City of Richmond
 Planning and Development Department

Report to Committee

File: RZ 08-408104
 12-8060-20-8440

Re: Application by Polygon Development 222 Ltd. for Rezoning at 9420, 9460, 9480, 9500 Odlin Road from Single-Family Housing District, Subdivision Area (R1/F) to Comprehensive Development District (CD/201)

ELEVATION
 DETAILS
 A4.3

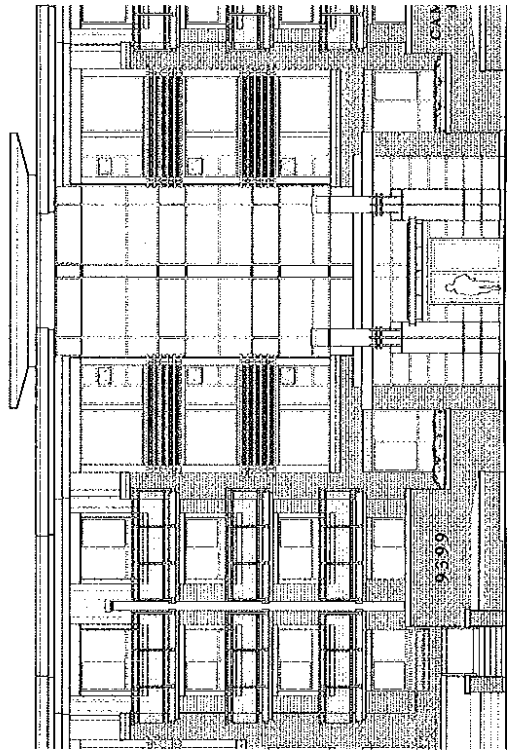
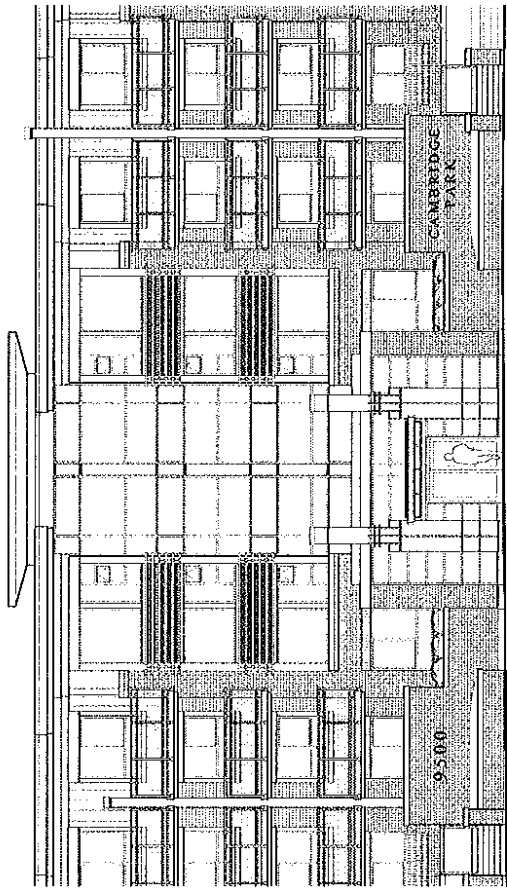
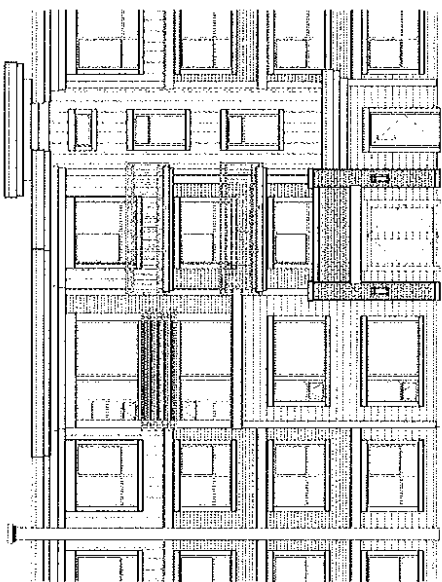
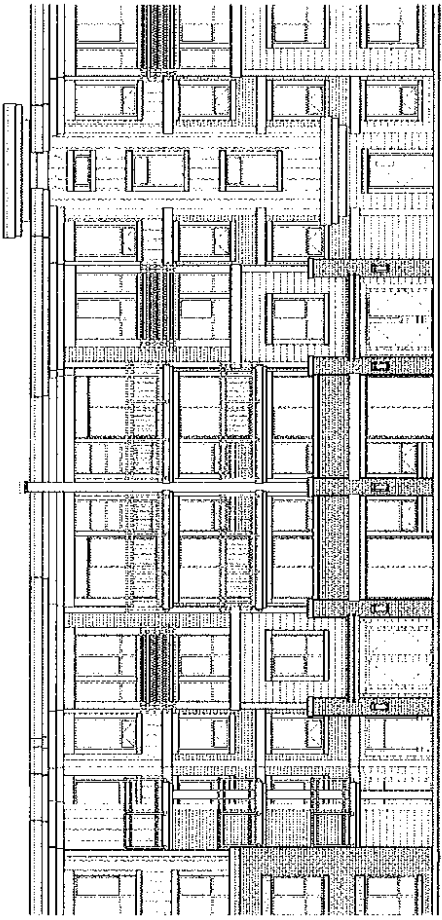
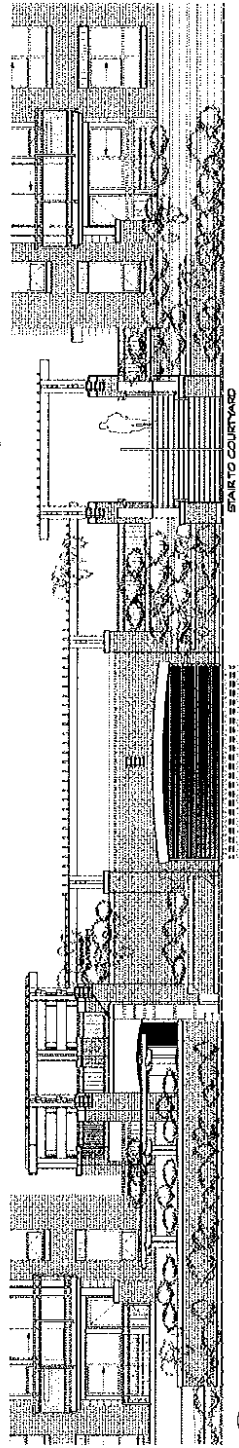
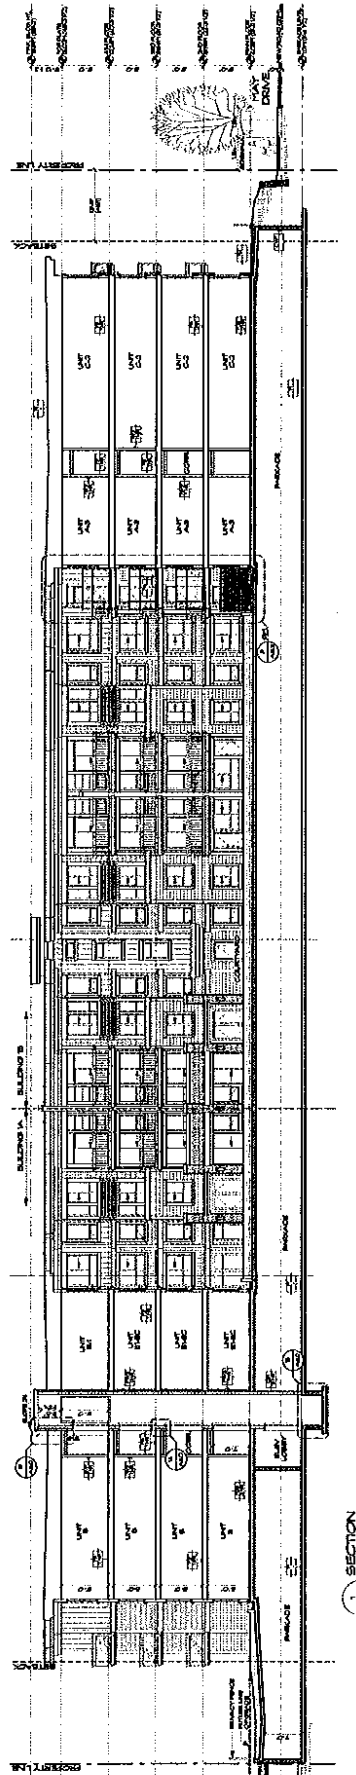
- 12. *consider adding contrast in colour or material changes to the areas around the entries to add punch to the entry areas;***

See attached elevations. Framing for the full height glazing has been changed to black to give higher impact and better differentiate the lobby. The entry area has been improved with increased detail and visibility of lobby.
